# The Corporation of the Town of Milton Committee of Adjustment and Consent

Thursday, March 27, 2025, 6:00 p.m. Council Chambers - In Person

Report To:	Committee of Adjustment and Consent		
From:	Taylor Wellings, MSc (PI), MCIP, RPP		
Date:	March 27, 2025		
File No:	A-25-005M		
Subject:	10 Bronte Street South		
Recommendation:	<ul> <li>THAT the application for minor variance BE APPROVED SUBJECT TO THE FOLLOWING CONDITIONS:</li> <li>1. That the development shall be constructed in accordance with the site plan prepared by Green Propeller Design and stamped by Town Zoning on February 12, 2025.</li> <li>2. That a Building Permit be obtained within two (2) years from the date of the decision; and</li> <li>3. That the approval be subject to an expiry of two (2) years from the date of decision if the conditions are not met, if the proposed development does not proceed and/or a building permit is not secured.</li> </ul>

Report To:	Committee of Adjustment and Consent		
From:	Taylor Wellings, MSc (PI), MCIP, RPP		
Date:	March 27, 2025		
File No:	A-25-006M		
Subject:	104 Barton Street		
Recommendation:	<ul> <li>104 Barton Street</li> <li>THAT the application for minor variance BE APPROVED

Figure 1 - Proposed Site Plan

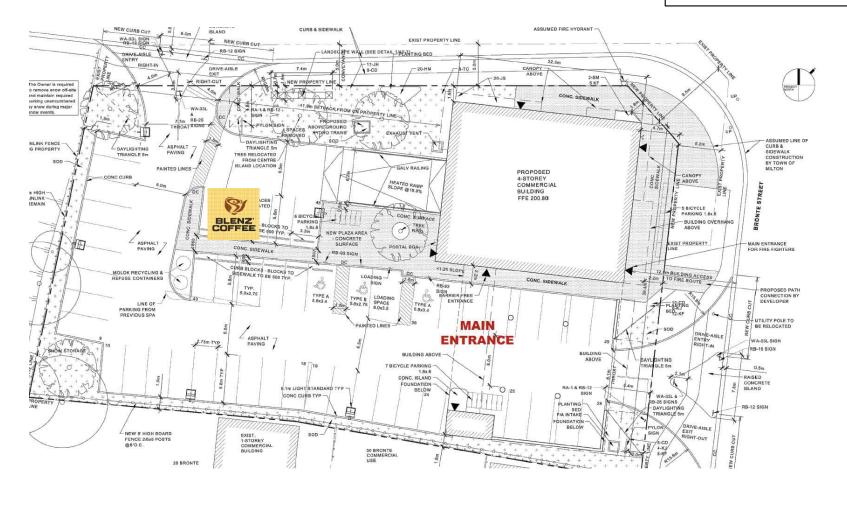
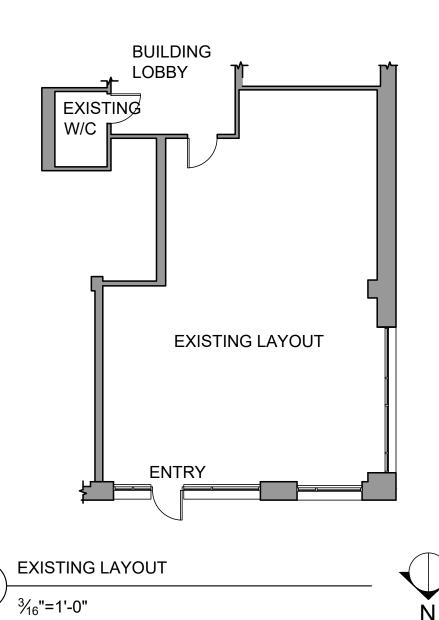
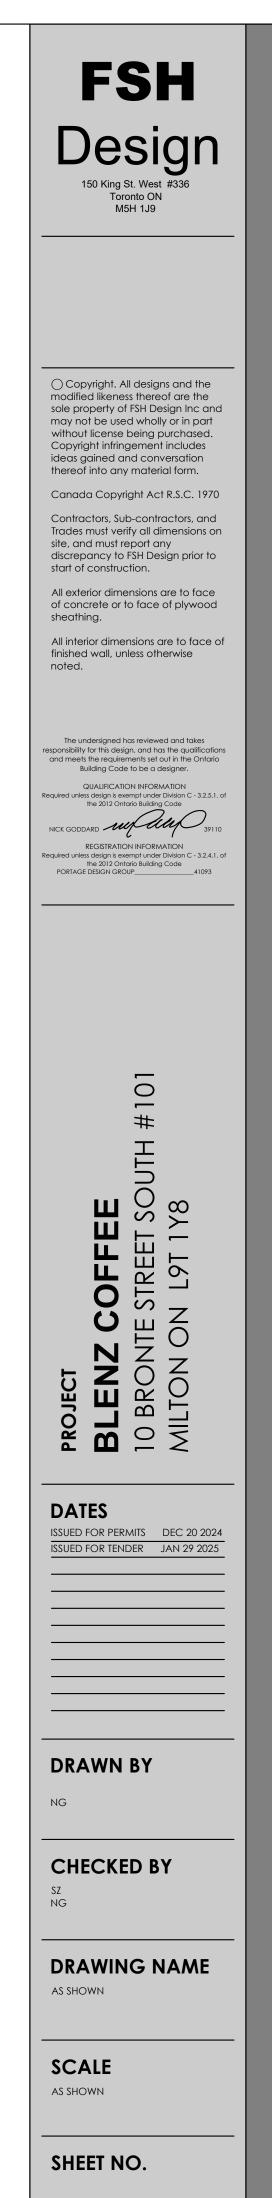
The applicant has requested a minor variance to facilitate the proposed development of a café use at the ground-level of the existing office use building. The applicant has requested to allow for 67 parking spaces, a difference of - 15 parking spaces, to facilitate the proposed development.

Planning staff have reviewed the minor variance application and have no concerns with the proposed development and requested reduction in required parking spaces. As noted above, Town Transportation staff have confirmed that the proposed reduction in parking spaces poses no concerns for the existing building and surrounding area. Further, on-street parking along Main Street as well as the two transit routes that operate along Bronte Street and Main Street will assist with parking relief. Surrounding area also includes an existing pedestrian network as well as cycling lanes also available in close proximity.

Figure 1 - Proposed Site Plan

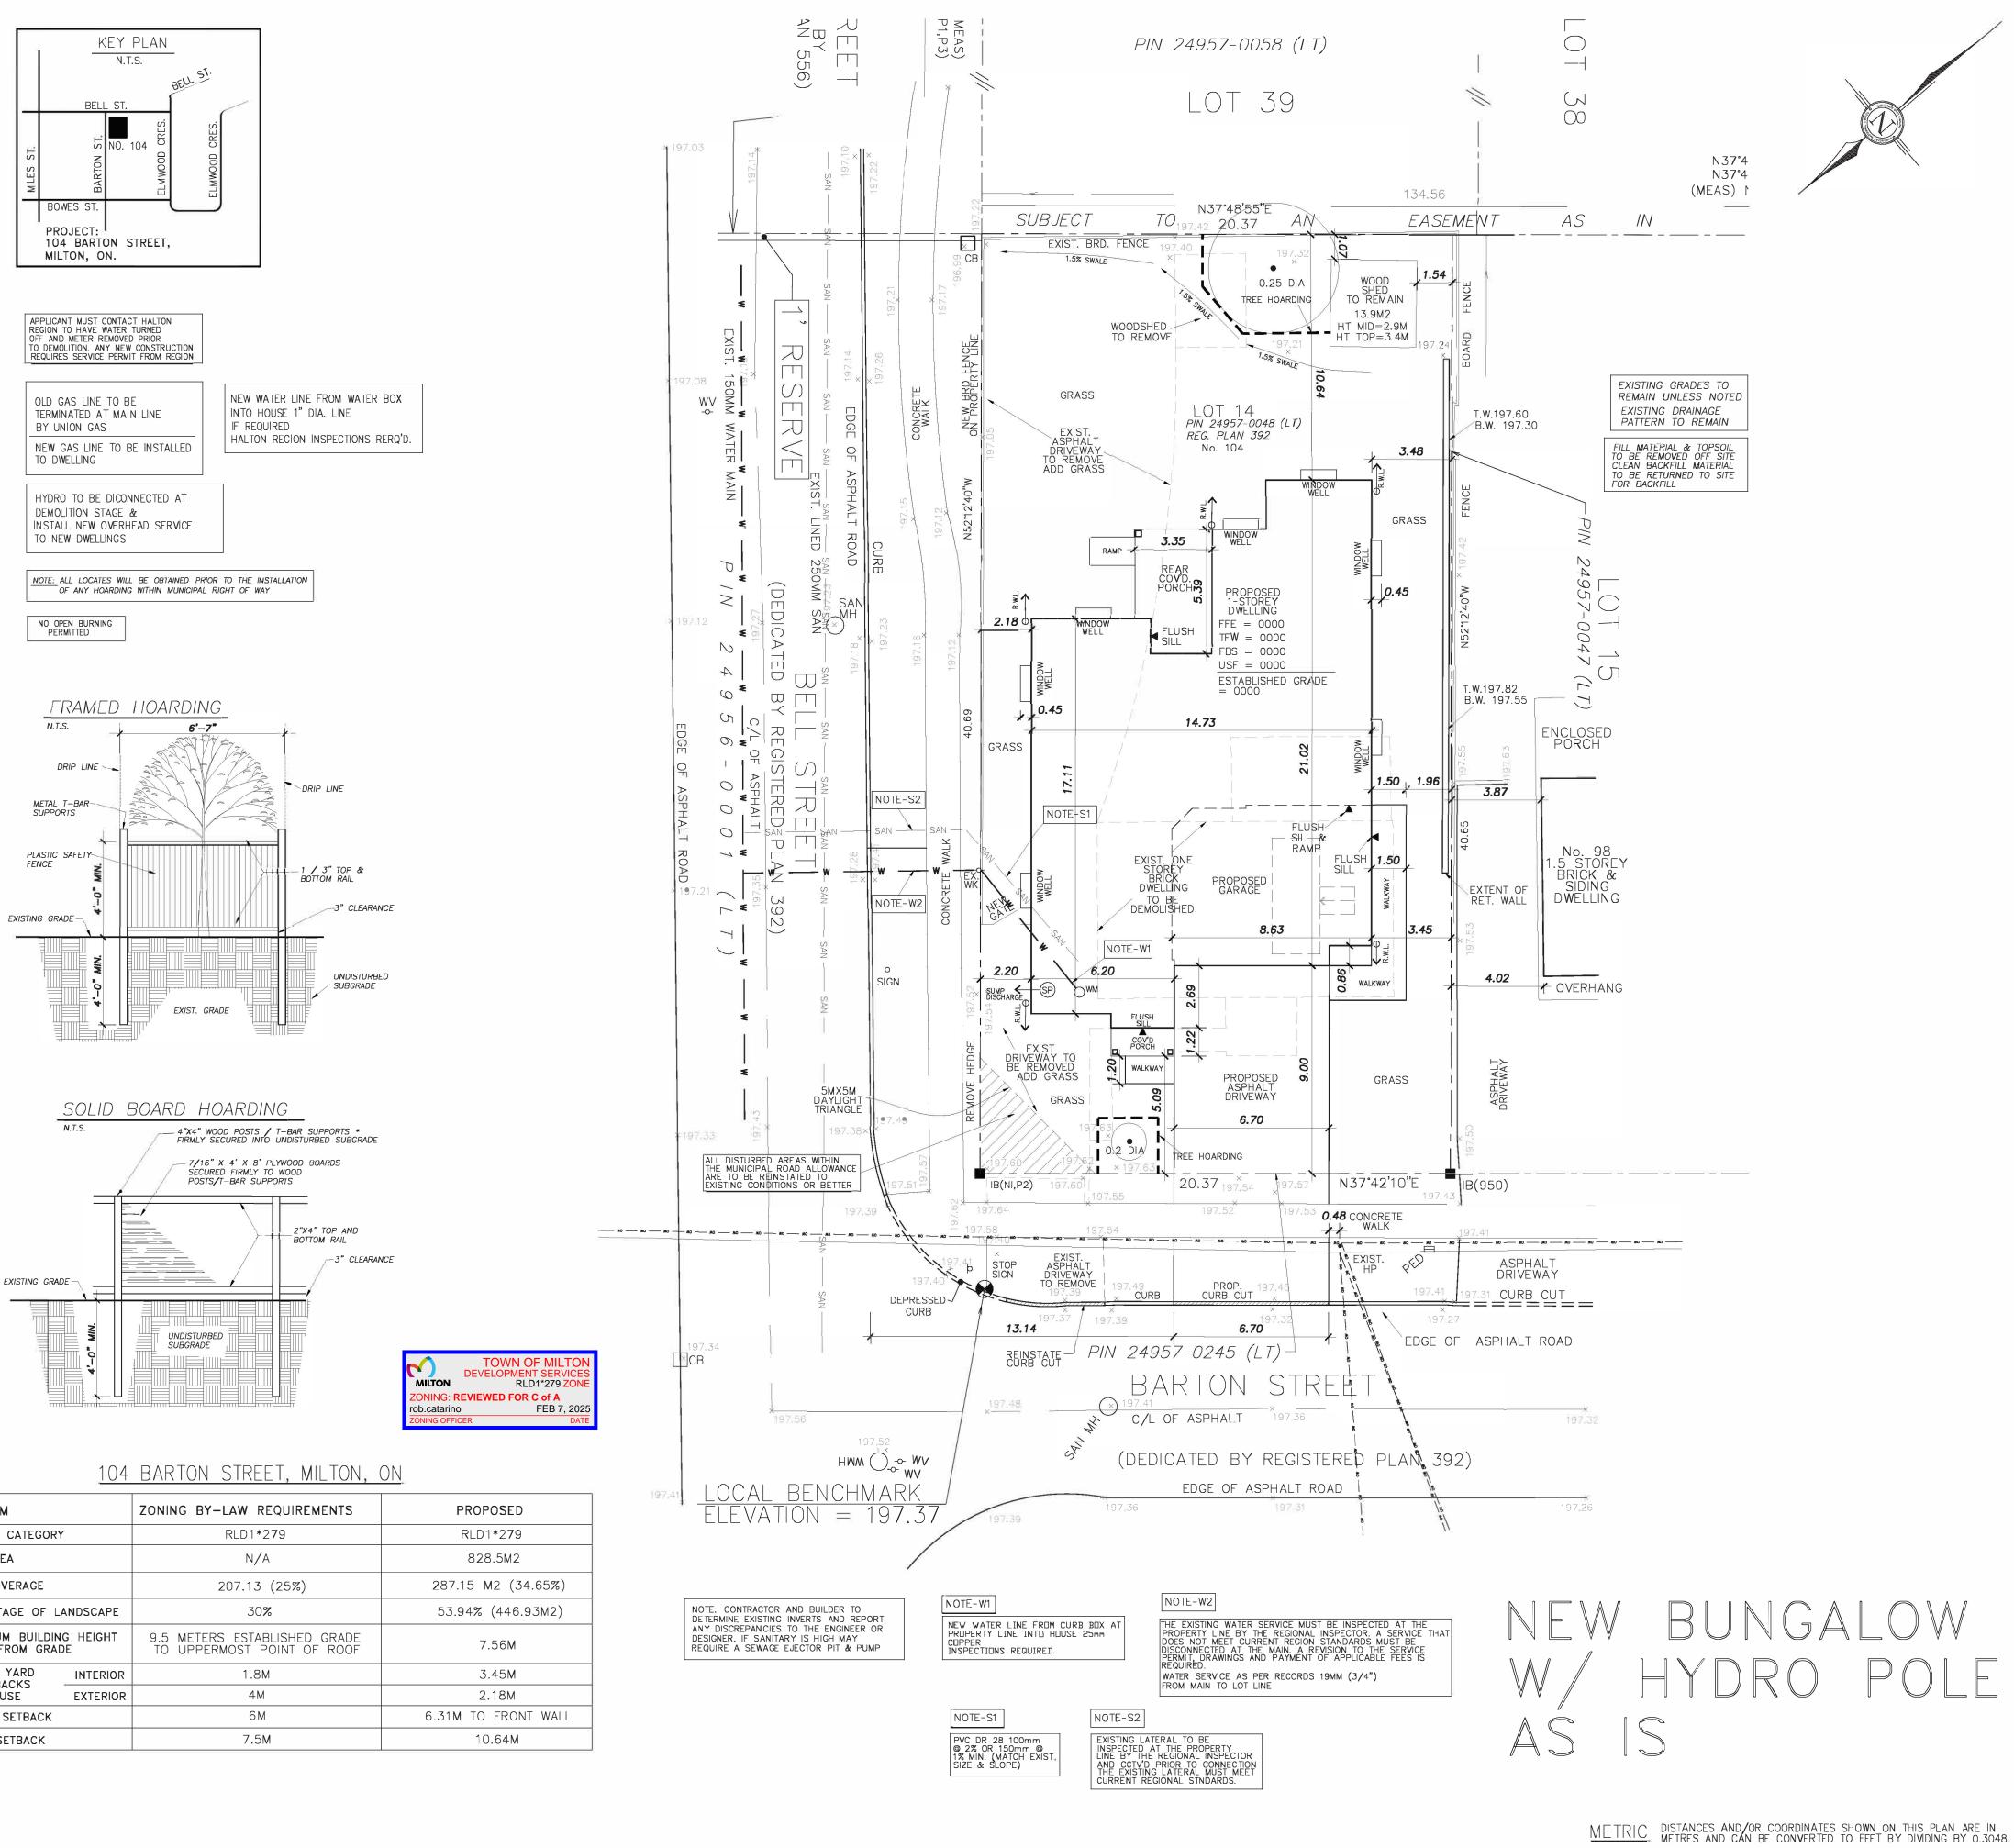
The applicant has requested a minor variance to facilitate the construction of a single-detached dwelling on the subject property. The subject property currently contains a single-detached dwelling and accessory structure (shed). The applicant has requested this minor variance application to facilitate the construction of a new single-detached dwelling and for the existing accessory structure (shed) to remain on the subject property. Further, the proposed single-detached dwelling will have a number of barrier free design elements which has prompted the need for the proposed variance request.

The applicant has requested permission to allow for the exterior side yard setback to be 2.18 metres, a difference of - 1.82 metres, to facilitate the proposed development. Planning staff have no concerns regarding the minor variance request as the proposed dwelling will remain setback sufficiently from the property line as well as the concrete walkway. Planning staff also note that no concerns were noted from a transportation or engineering perspective.

The applicant has requested permission to allow for a lot coverage of 34.65%, a difference of + 9.65%, to facilitate the proposed development. Planning staff are of the opinion that the proposed increase required in lot coverage required to facilitate the design of the detached dwelling is appropriate and have no concerns.

Planning staff had conversations with the agent on file who provided information on the house requiring design specifications from an accessibility perspective for the homeowners. The agent on file did provide a breakdown for the lot coverage request which detailed design elements for the dwelling such as a garage bump out to allow for wheelchair accessibility as well as a wheelchair lift needed in the mudroom. Planning staff have no concerns regarding the proposed lot coverage increase and as noted above, Engineering staff will require further information to ensure there are no outstanding stormwater or site grading concerns and these have been included as a condition of development approval.

The applicant has requested permission to allow for the dwelling face to be 42.1% of the building face, a difference of - 7.9%, as well as requested permission to allow for a garage face to be setback 2.69 metres, a difference of - 2.81 metres from the building wall, to facilitate the proposed development. Both requests have come forward as part of the homeowners design to create a barrier free bungalow style home. The design elements proposed are minor in nature and the proposed dwelling will not negatively impact the surrounding residential area. Planning staff have no concerns with the request variances.

Town engineering staff have reviewed the application and will require a Stormwater Management Brief that provides additional information from a stormwater management perspective as well as a Site Grading & Site Servicing Plan. Both requirements have been included as a condition of development approval.

Figure 1 - Proposed Site Plan

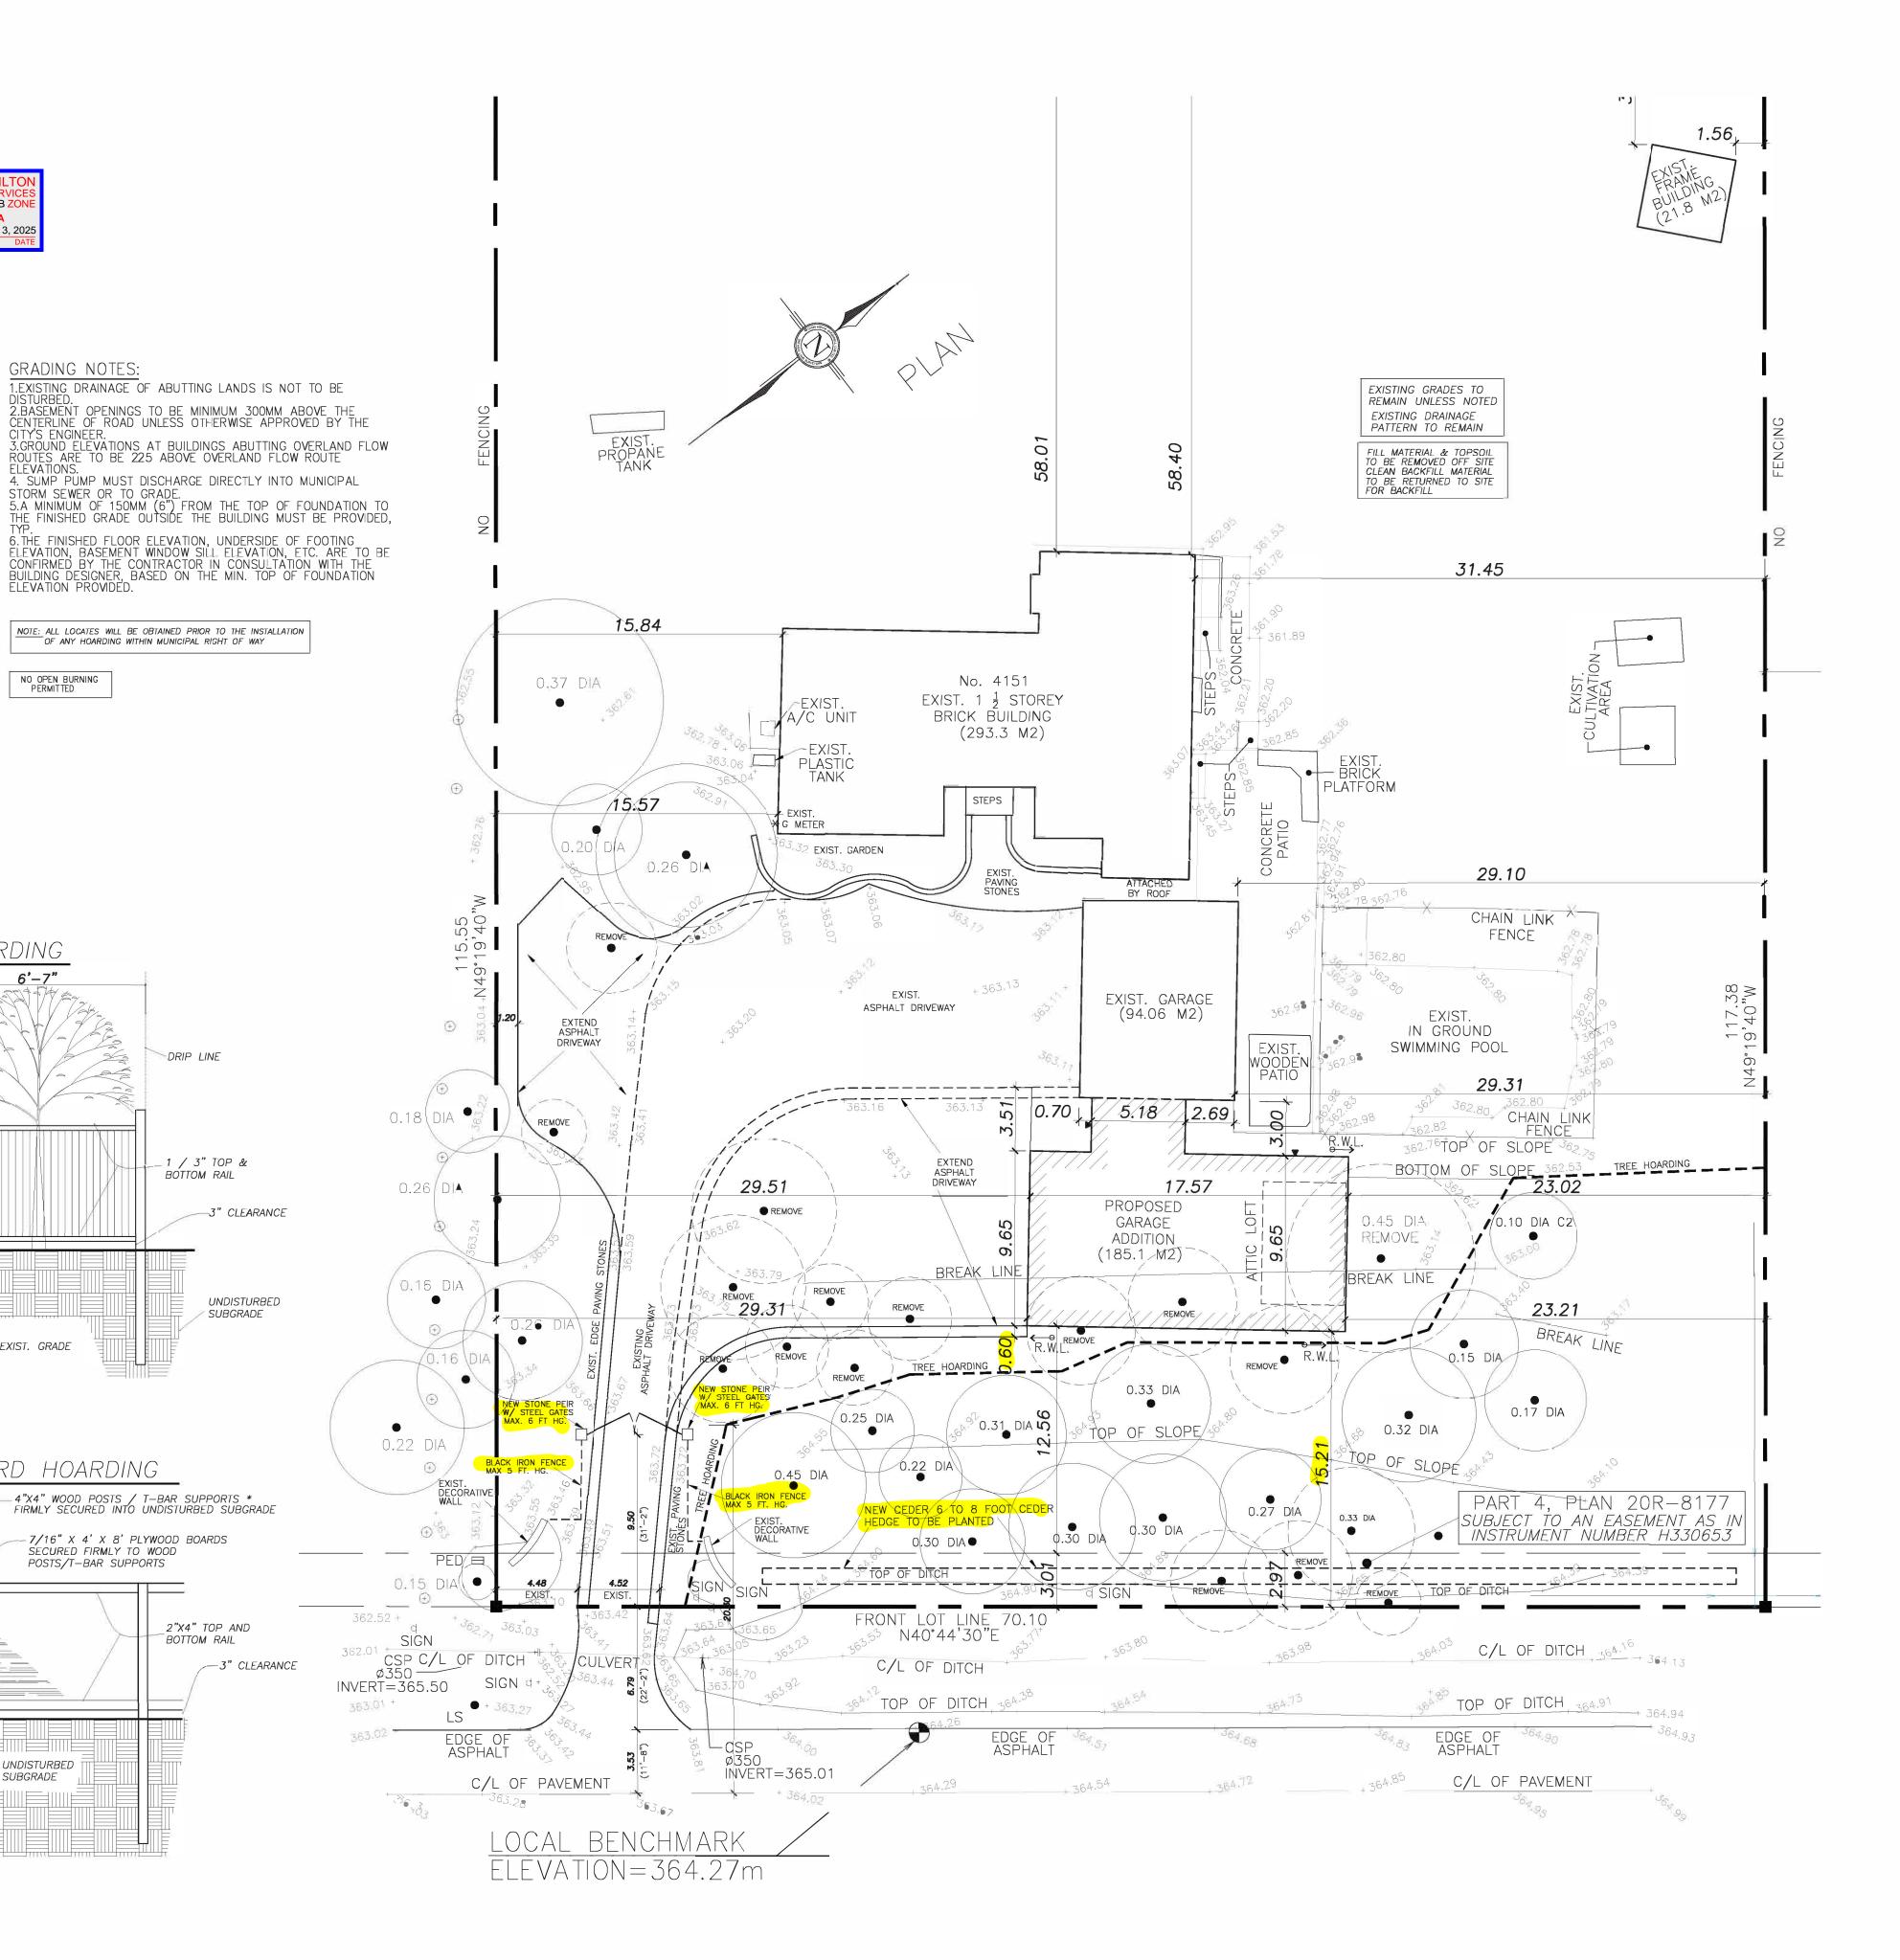
The applicant has requested permission to allow for a minimum front yard setback of 15.21 metres, - 8.79 metres, to facilitate the proposal. Planning staff are of the opinion that the request for the minimum front yard setback is minor in nature and does not negatively impact the subject property or surrounding properties. The proposed garage addition is an extension of the existing garage and Planning staff feel it is the most appropriate location as it is within the existing building cluster. As noted above, a Tree Planting Plan and Arborist Report was provided which confirmed the

location of the trees to be removed and planted and staff are of the opinion that this will assist with the visual impact of the structure. Planning staff do not have concerns with the minimum front yard setback request as the garage addition will remain sufficiently setback from the property line.

The applicant has requested permission to allow for two (2) attached garages on a lot, + 1 garage, to facilitate the proposal. Planning staff do not have concerns with the proposed additional garage as it would not be considered overbuilding on the subject property as enough space remains. The proposed additional garage is an extension of the existing and will provide the homeowners with additional storage. Planning staff do not have any concerns.

The applicant has requested permission to allow for a garage door height to be 3.05 metres, + 0.65 metres, to facilitate the proposal. Planning staff are of the opinion that the proposed increase in maximum height for the garage door of the garage addition is minor in nature and requested to allow for the homeowner to park personal vehicles and a boat in the garage. The garage addition meets the zoning provisions for maximum height and the garage door increase will not impact the surrounding property owners.

The applicant has requested permission to allow for a driveway to exceed beyond the garage face a maximum of 0.60 metres, to facilitate the proposal. The variance request for the driveway extension is to allow for the homeowner to maneuver into the driveway as well as park personal vehicles such as a boat trailer. Town staff do not have concerns with the proposed driveway extension.

The applicant is requesting permission to allow a maximum height of 1.83 metres for the iron fence and gate, + 0.83 metres as well as 2.44 metres for the cedar hedge, + 1.44 metres, to facilitate the proposal. It should be noted that the proposed cedar hedge is subject to the Town's Zoning Bylaw as it is considered to be a fence and serving as a boundary along the front of the property. The proposed iron fence and gate as well as cedar hedge do not pose any sight line concerns for the property owner or surrounding properties. Planning staff do not have any concerns with the request and appreciate the cedar hedge addition given the tree removal necessary to accommodate the proposed development.

Report To:	Committee of Adjustment and Consent			
From:	Taylor Wellings, MSc (PI), MCIP, RPP			
Date:	March 27, 2025			
File No:	A-25-007M			
Subject:	4151 Ennisclare Drive			
Recommendation:	<ul> <li>THAT the application for minor variance BE APPROVED SUBJECT TO THE FOLLOWING CONDITIONS:</li> <li>1. That the development shall be constructed in accordance with the site plan prepared by Jansen Consulting and stamped by Town Zoning on March 3, 2025;</li> <li>2. That the Arborist Report and Tree Planting Plan be executed by the homeowner during and after construction of the proposed development;</li> <li>3. That a Building Permit be obtained within two (2) years from the date of the decision; and</li> <li>4. That the approval be subject to an expiry of two (2) years from the date of decision if the conditions are not met, if the proposed development does not proceed and/or a building permit is not secured.</li> </ul>
